Service Bulletin: 1202002SR: Spacing of Wing to Fuselage attachments

SR-3500 SERIES AIRCRAFT

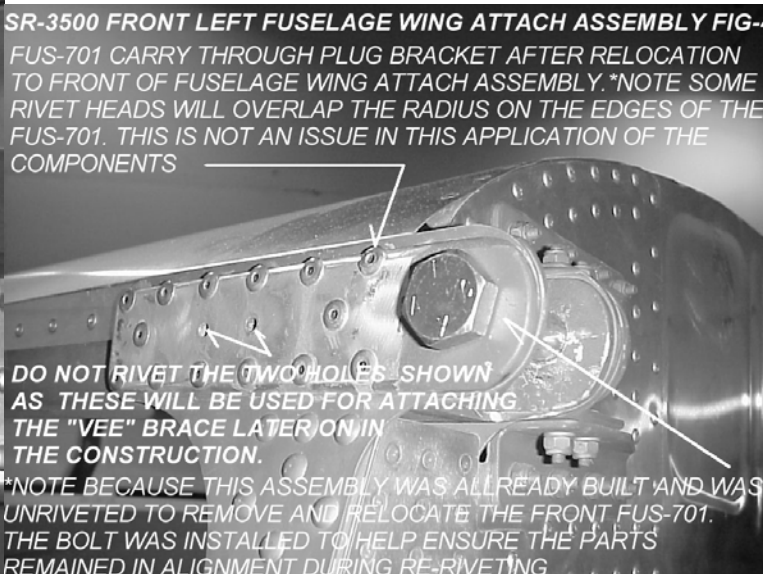
The illustration in Fig 1 below shows the nature of the problem. The "Outside" fore to aft spacing of the W-710 & W-709 front attach brackets to the W-713&W-714 rear attach brackets on the wings, exceeds that of the fuselage receiver fittings spacing. Uncorrected the resulting fore and aft pre-loads on the rear wing attach fittings will cause them to bend. This must be corrected prior to fitting the wing to the fuselage. The rear wing attach fittings must be completely free of fore and aft pre-load during assembly. This is accomplished by adjusting the fit and location of the combined W-710 and W709 fittings within the front fuselage wing attachments. See fig 2 below.

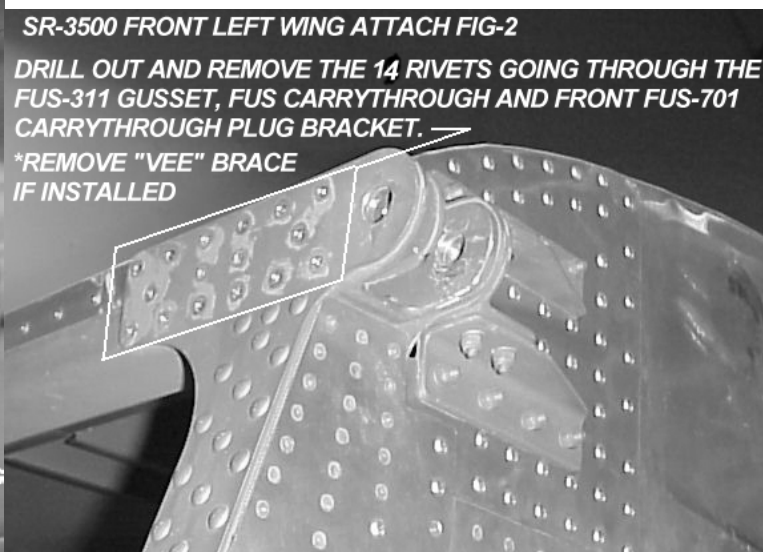
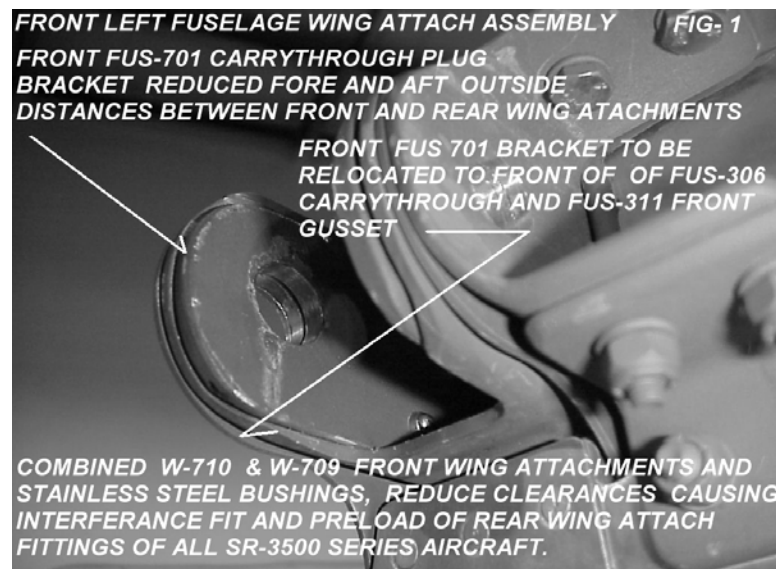
The fitting of the SR3500 series wings to the modified SR3500 fuselage front wing attach fittings has caused an unacceptable interference fit on two fast-build aircraft being assembled at the factory.

FIG-3 AND FIG-4B illustrate how to remedy the spacing problems. If further details are required please notify the technical department.
 A large printable version of these photos will be made available shortly.
